Technical Service Bulletin

72 Rattle from left rear seat back

72 13 12 2030729/4 October 21, 2013. Supersedes Technical Service Bulletin Group 72 number 13-05 dated September 5, 2013 for reasons listed below.

Model(s)	Year	VIN Range	Vehicle-Specific Equipment
Audi Q5	2009 - 2012	All	Not Applicable
Audi Q5	2013	000001 - 009164

Figure 3. 2/3 seatback frame

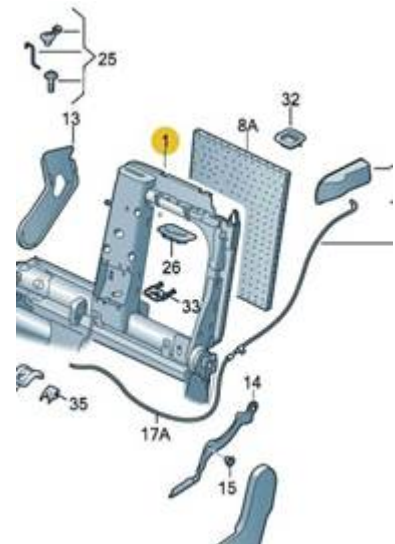
1. Start diagnosis by performing a test drive. Sit in the right rear seat of the vehicle while a partner drives.
2. Ensure that there are no objects or passengers in the left rear seat, as the rattle is best diagnosed under these conditions.
3. If the 2/3 rear seatback is confirmed as the source of the rattle, the 2/3 rear seatback frame must be replaced, as the 2/3 rear seat backrest frame is not serviceable (Figure 3).
